3rd May 2024

Development Application No. DA2023/1869 Issues response/ Supplementary Statement of Environmental Effects Demolition works and construction of a residential flat building 54-58 Beaconsfield Street, Newport

Attachment 1 Schedule of amendments

Figure 1 – Plan extracts showing portion of eastern wall setback 4 metres from eastern boundary.

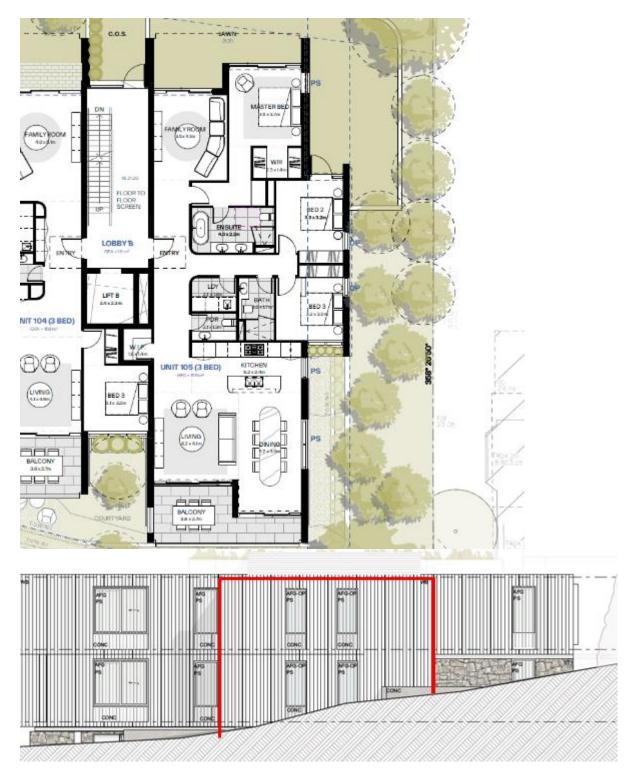
The proposed 6m eastern side setback is generally acceptable. However, a
portion of this façade is pushed toward the boundary approximately 8.75m
long. This wall presents as a large unarticulated mass to a low density
residential area and should be set back further or reduced in length to provide
an appropriate transition to the low density zoning. This is particularly
relevant as this is the only area on site which would provide 6m for deep soil
planting without any structures (noting the large amount of retaining walls to
the front setback required for the lowered POS areas).

The section of eastern wall referred to by DSAP is depicted in Figure 1 overpage. Based on a wall height between 5 metres and 6.2 metres for the portion of wall referred to by DSAP the required side boundary setback is between 3.75 metres and 4.05 metres. Accordingly, this portion of wall is compliant with the applicable side boundary setback control.

In relation to the DSAP concern regarding articulation and landscape opportunity we are of the opinion that the variation in the side boundary setbacks, which varied between 4 and 6 metres, provide an appropriate level of built form articulation as it presents to the adjoining R2 Low Density Residential zone with the majority of the façade setback 6 metres, well in excess of the DCP setback provision, in recognition of the sites zone boundary interface.

The basement plan and landscape plan extracts at Figure 2 demonstrate that the amended plans provide for substantial deep soil landscape opportunity along the entire eastern setback area of the development with appropriate dense landscape screening to soften screen this façade of the building.

The eastern side boundary setbacks are compliant and contextually appropriate under the circumstances.
